File No. 251094 **Committee Item No.** _____
Board Item No. 19

Re: California Environmental Quality Act (CEQA) Exemption Determination Appeal

RE: Appeal of CEQA Exemption Determination by Planning Commission for 350 Amber Drive Project on September 25, 2025 – (Record No. 2024-004318ENV)

ADOPTING FINDINGS RELATING TO A CONDITIONAL USE AUTHORIZATION PURSUANT TO PLANNING CODE SECTIONS 211.2 AND 303, TO INSTALL A NEW AT&T MACRO WIRELESS TELECOMMUNICATIONS FACILITY ON AN APPROXIMATELY 104-FOOT-TALL MONOPOLE, CONSISTING OF (12) NEW ANTENNAS; (9) NEW REMOTE RADIO UNITS AND ANCILLARY EQUIPMENT. THE SUBJECT PROPERTY IS LOCATED AT 350 AMBER DRIVE, LOTS 005 IN ASSESSOR'S BLOCK 7521, WITHIN THE P (PUBLIC) ZONING DISTRICT AND OS HEIGHT AND BULK DISTRICT, AND ADOPTING FINDINGS UNDER THE CALIFORNIA ENVIRONMENTAL QUALITY ACT.

ELEVATION VIEW

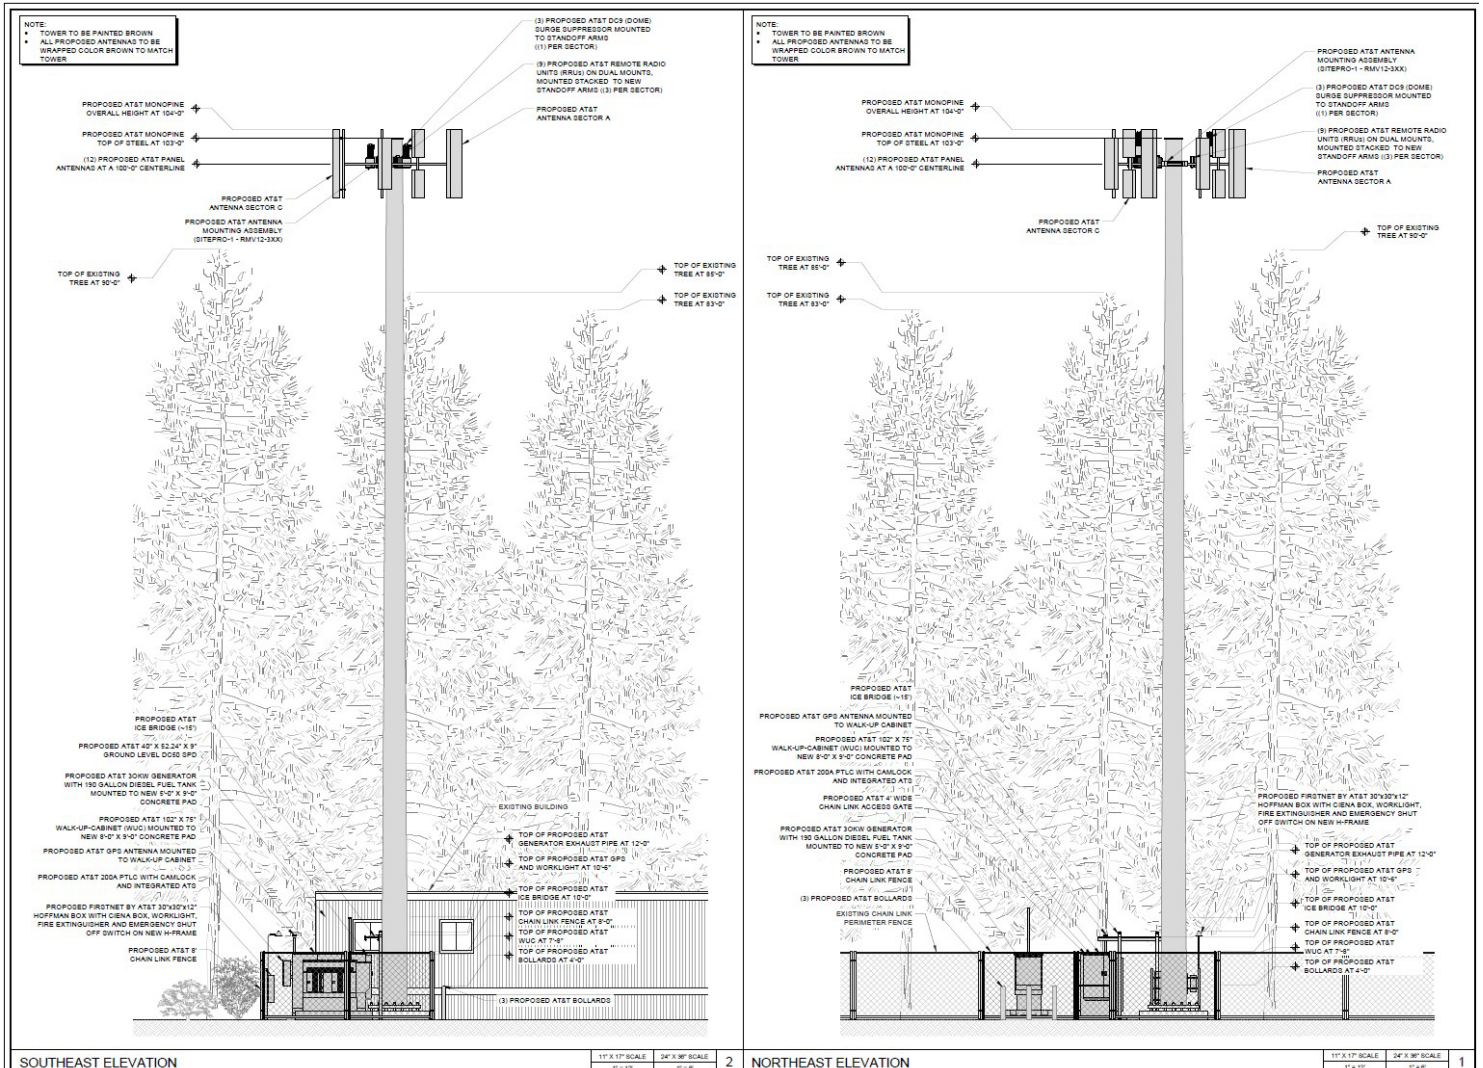
THE PROJECT MEETS THE DEFINITION FOR A CLASS 3 CATEGORICAL EXEMPTION

- CEQA Guidelines section 15303, or Class 3, applies to projects proposing the construction and location of limited numbers of new, small facilities or structures; installation of small new equipment and facilities in small structures…
- Class 3 includes a wide range of activities concerning new, small facilities or structures, which allows commercial structures up to 10,000 square feet, for example.
- The project proposes to install modestly-sized equipment in a small footprint and with maximum height comparable to the surrounding trees.

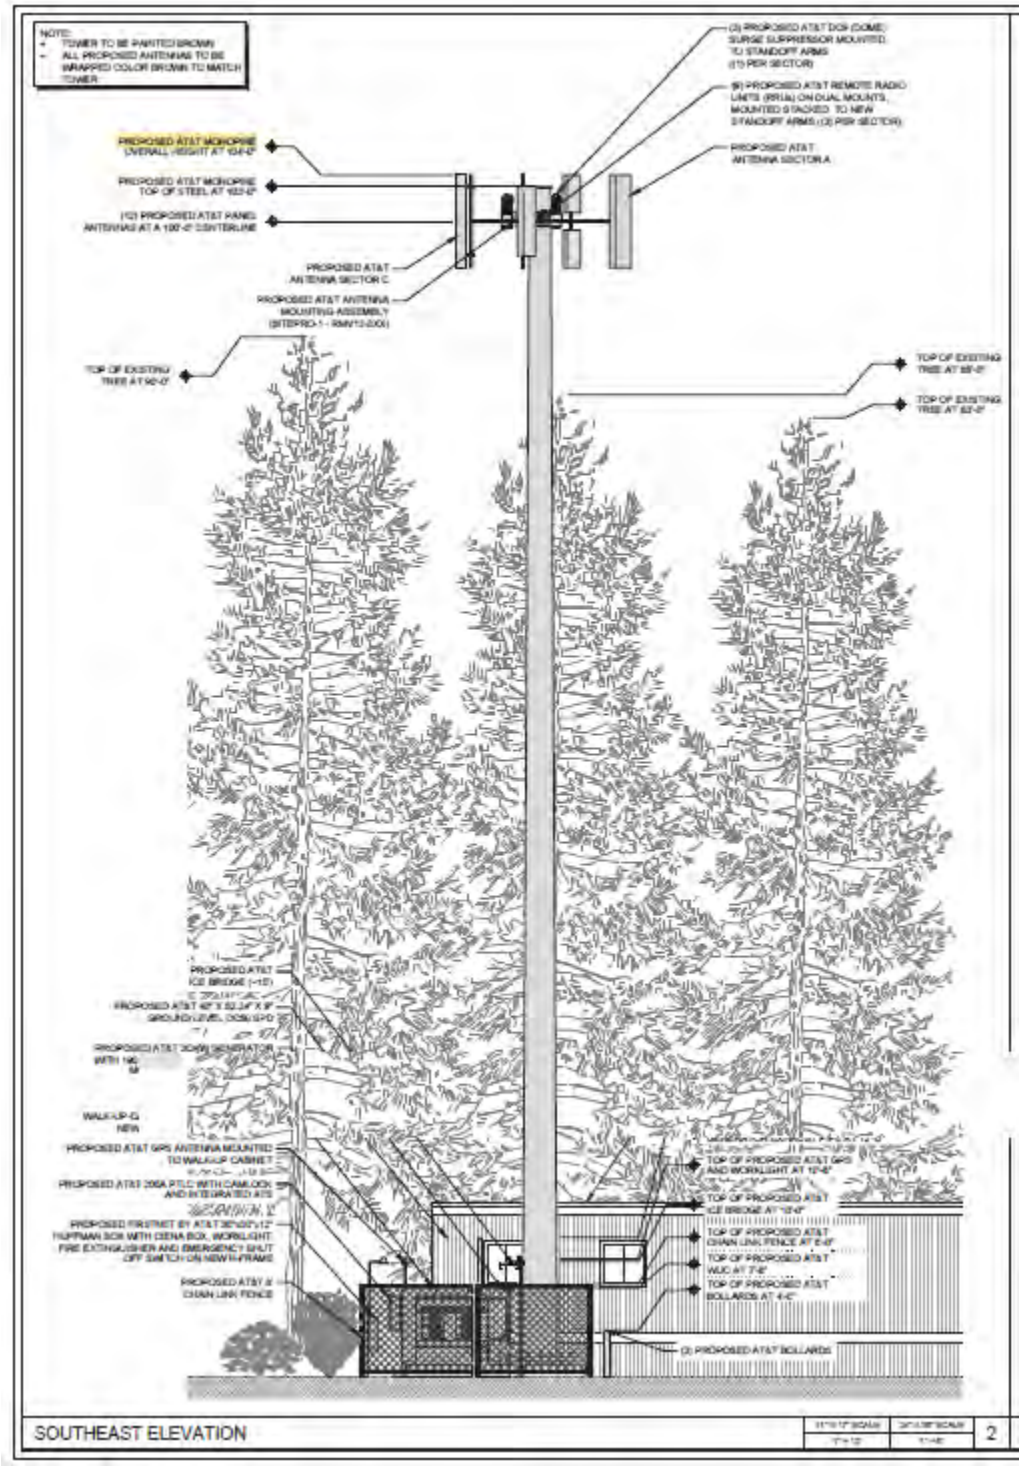
To wit, the Project proposes a 104-feet tall monopine or monopole, surrounded by 90-feet eucalyptus tree grove, as depicted on the screenshot from the Project plans below:
